# SAFETY RECALL BULLETIN

## NHTSA RECALL 16V723, Transport Canada 2016-504

AUTOCAR INDUSTRIES, LLC SAFETY RECALL MDTT-1602 REV. 001

Autocar has determined that a safety defect exists in the steering linkage assembly of certain 2015-2017 model-year Xspotters and Xperts.

**Figure 1**  
**Single Drive Xpert**

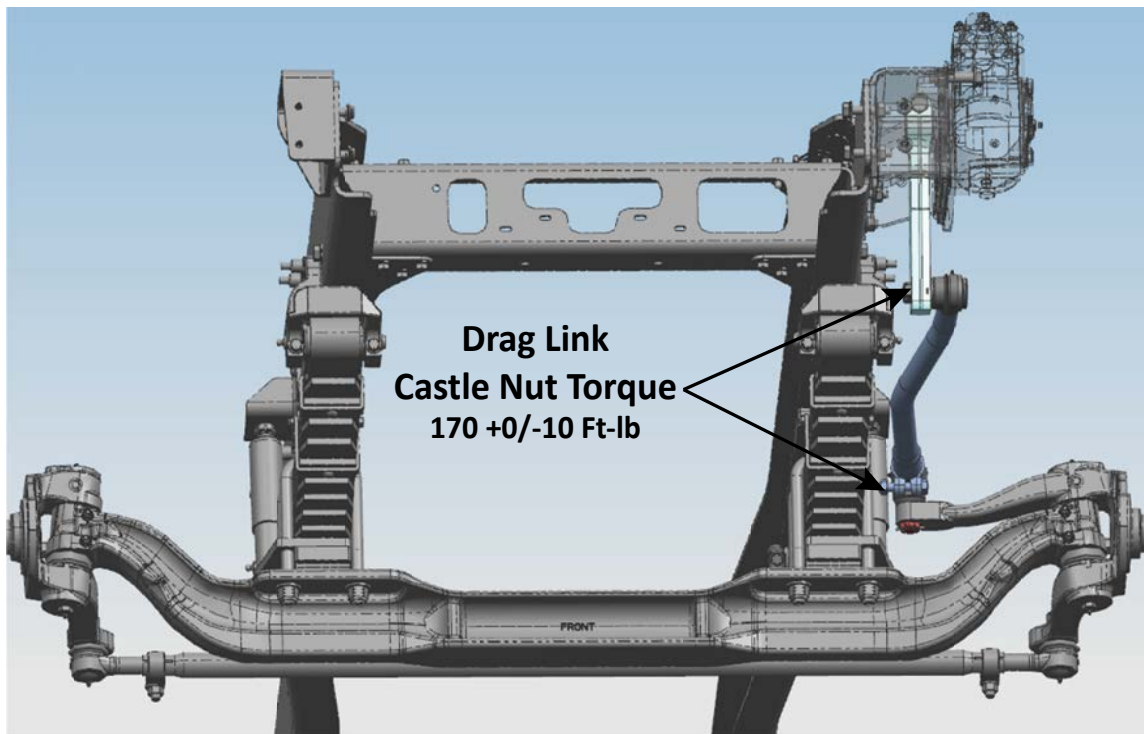
1. Raise the cab. Refer to the Safety Notices on page 2. Make sure that you read and understand the safety precautions before proceeding.
2. Locate the castle nuts on the drag link. Remove the cotter pins and discard (See Figure 1 for Single Drive Xpert, Figure 2 for Dual Drive Xpert or Figure 3 for Xspotter).

**Figure 4**

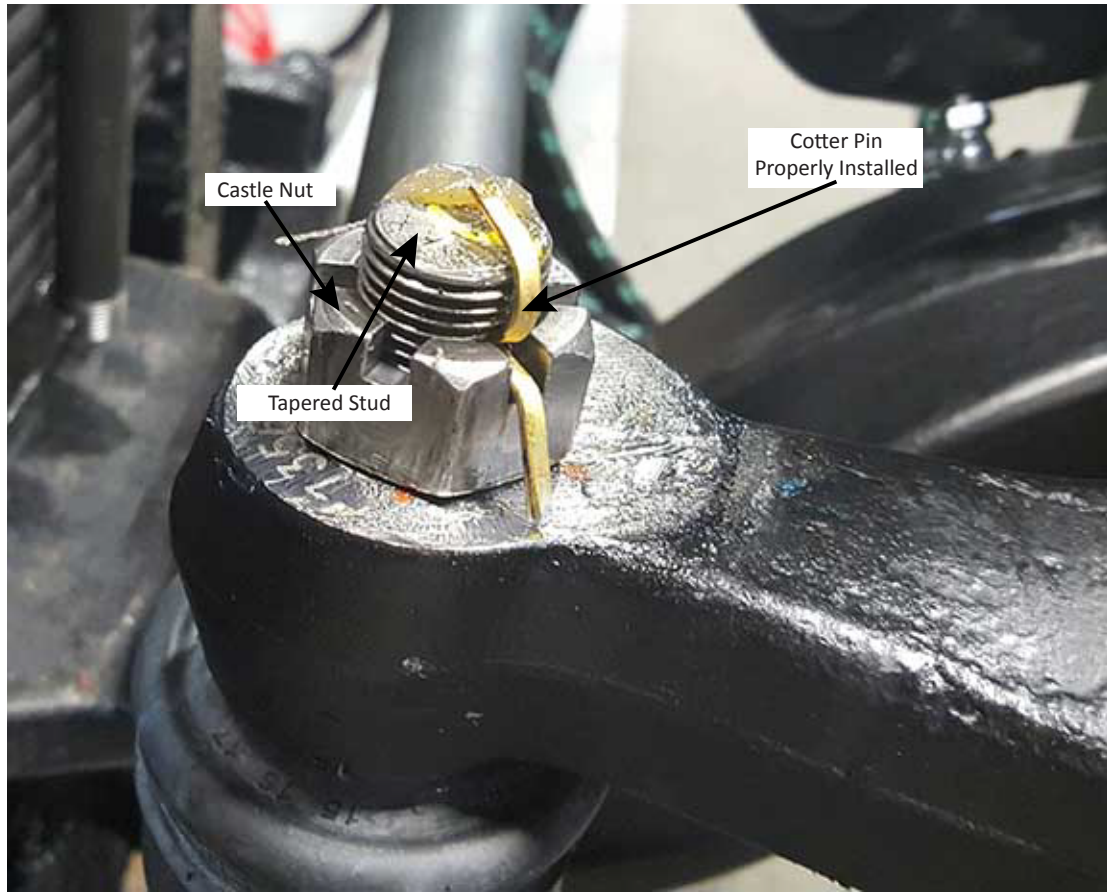
3. Un-screw the castle nut by rotating it counter-clockwise until the castle nut turns freely. Using hand force only, check for any movement of the tapered stud within the steering arm/pitman arm. Inspect each tapered stud (See Figure 4). If there are any signs wear or fretting on the contact surface between the castle nut and the steering arm/pitman arm, or if there are any signs of loose fit or movement or rotation within the steering arm or pitman arm, or if the nut will not tighten to the specified torque (See Torque Chart below), call Autocar technical support at 888-218-3611.

5. Install a new cotter pin through the hole and bend one leg toward the back of the castle nut and the other up around the end of the threaded fastener (See Figure 4).

Torque Chart				
Component	Thread Size	Socket Size	Ft-lb	+/-
Drag Link Castle Nut	7/8"-14	1 5/16"	170	0/10
